COMBINED PRELIMINARY AND FINAL
DRAINAGE REPORT
for
OHANA SUBDIVISION
EL PASO COUNTY, COLORADO

Allison Engineering 4245 Log Road
Peyton, CO 80831

Figure 5: Diagram of the area drained at the existing 16-inch culvert.

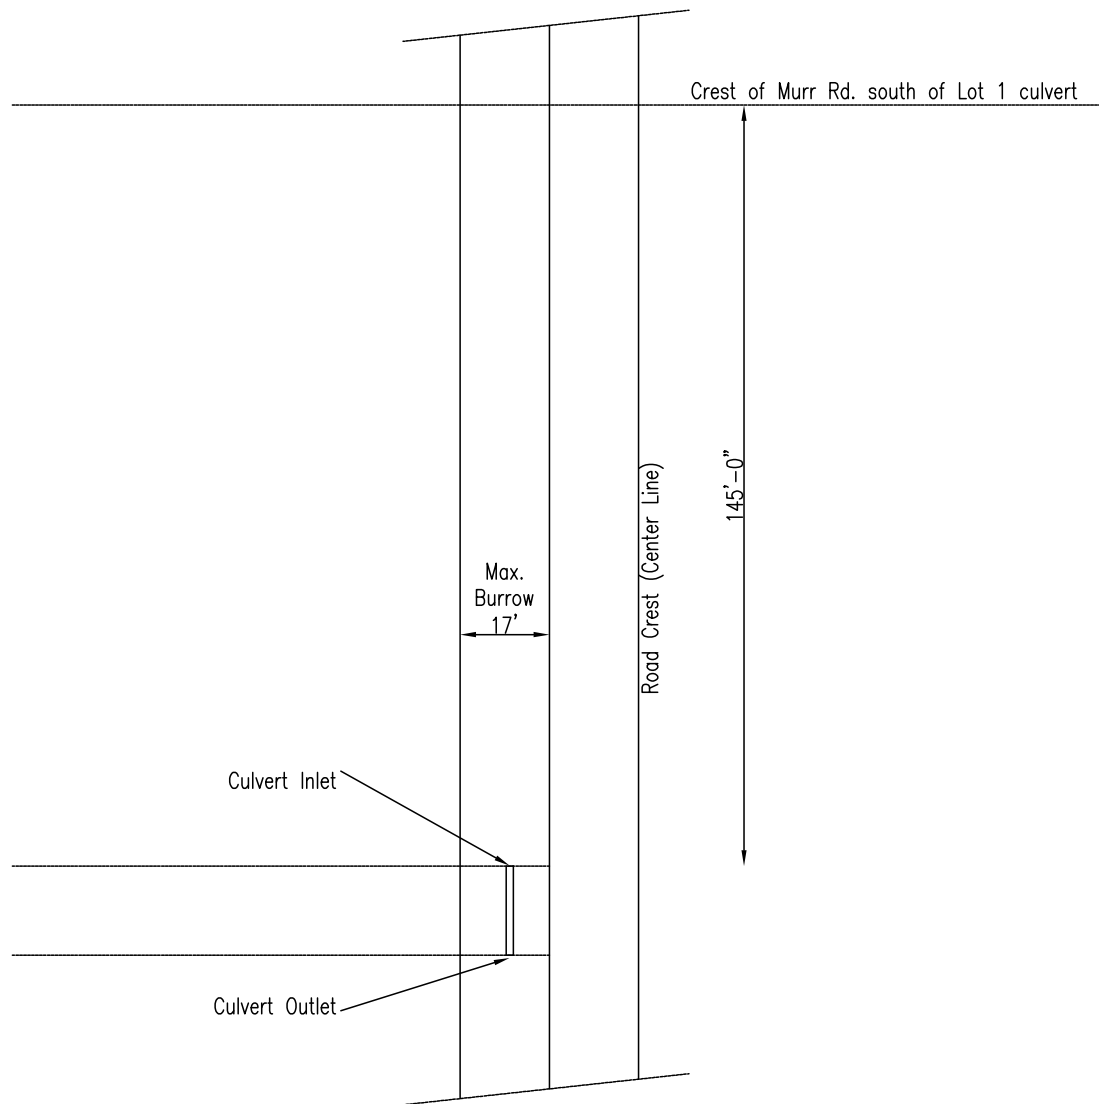
Appendix only goes to Figure 7. Please update reference.

Figure 7: Small plat plan of proposed subdivision. Larger print accompanies this report.

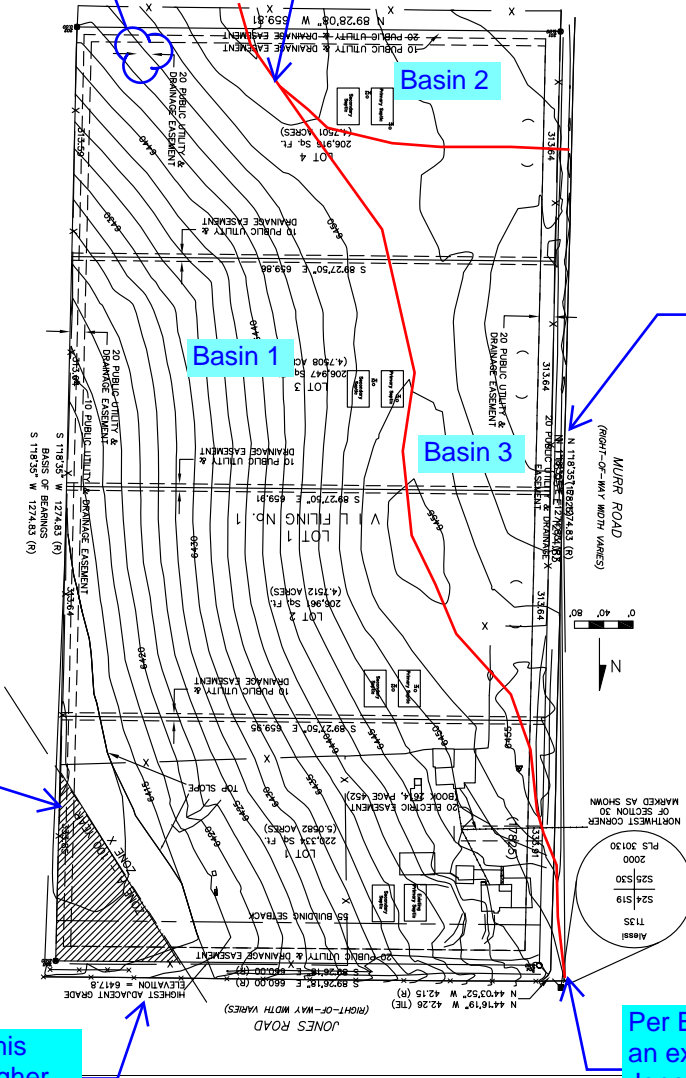
Need to clearly show what is existing vs. what is proposed.

Rotate map so text is upright and north points to top of page.

Provide map that is to scale & provide legend

Label all adjacent property owners

Show drainage arrows

Show and label existing culvert mentioned in report

Missing easement lines for this note.

It appears that there is a ridge running through the project site. A drainage basin with flows for each will need to be shown and calculated.

Fix overlapping text

Label no-build area for floodplain

Not sure of the intent of this statement as there are higher elevations along the roadway.

Per EPC GIS information an existing culvert crosses Jones Rd at intersection. Please show and label.
